Technical Service Information

THM 440-T4 BACKS UP IN NEUTRAL

86-48

Figure 1

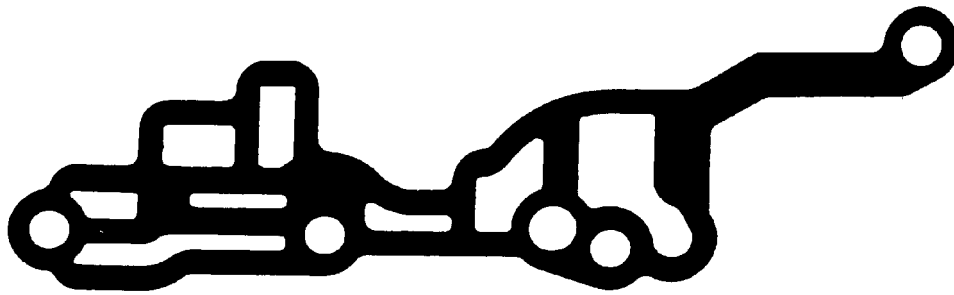
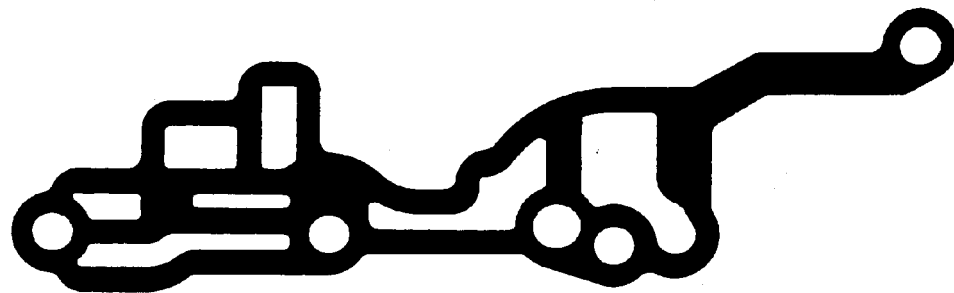
- COMPLAINT:** Car moves in reverse with manual lever in neutral Engine lugs with transmission selector in park
- CAUSE:** Could be a cross leak in the RNDI oil passage in the Case cover due to the use or installation of the wrong Upper case cover gasket,
- CORRECTION:** In figure 1 we illustrate the early gasket which went with the Early case cover, the gasket in figure 2 is the late gasket That goes with the new case cover, by mis-matching the late Style gasket with the early cover it allows park-reverse neutral Oil to apply the reverse band with the transmission selector In neutral, (keep in mind that the input clutch is applied in Neutral and park, bringing on the reverse band engages all the Components for reverse), the early gasket can be used with the -late cover, but the late will not fit the early, install the proper gasket

**EARLY GASKET WILL FIT LATE UNIT BUT LATE GASKET
WILL NOT RETRO FIT EARLY UNITS**
